**ICC IS-BLE COMMITTEE
COMMITTEE MEETING NOTES
Meeting #26
3-6-2023**

Date/Time: 3-6-2023; 2:00 p.m.-4:00 p.m. Eastern

The following was a suggested figure:

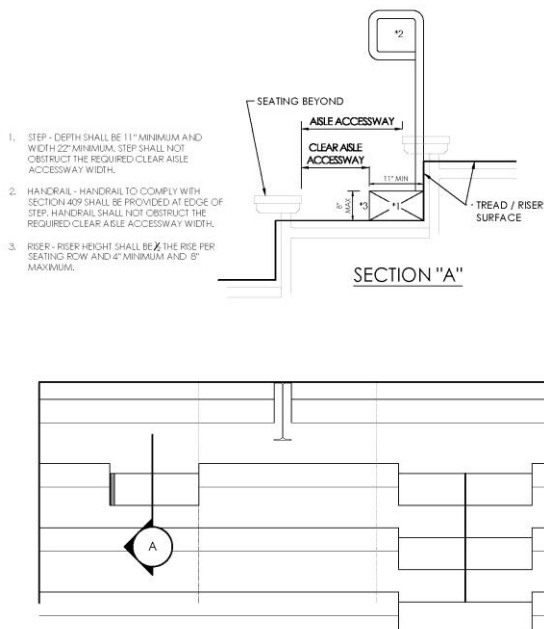
The current text had some concerns about obstruction of the aisle accessway. There were concerns about this being too broadly used by designers when this should have limited application. There was concern about the possible drop off if the seats in front of the step were removed to meet the clear aisle accessway width at this location.

The committee felt that this option was a very limited situation and could be addressed on a case-by-case basis via alternative means. There were alternative layouts of the aisles or removal of seats in front of the columns that could provide access without moving up and down between aisle accessways.

Upon further consideration, the committee voted to modify the proposal to delete the exception to Section 407.1 and the new 408. 7-2-0

The final vote for this proposal for as modified – 405.1, 405.2 and 407.1 without the exception – 9-0-0
